Lead Local Flood Authority

Date 19 September 2025

RE: DM/24/3051 – Highfields, West Hill, East Grinstead, RH19 4DL

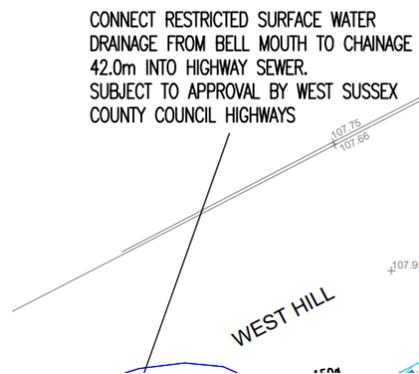
- 3) Please can the Applicant provide details of any proposed mitigation against the above.
- 4) The revised drainage plan contains the below note, which should now be removed given the revised proposal:
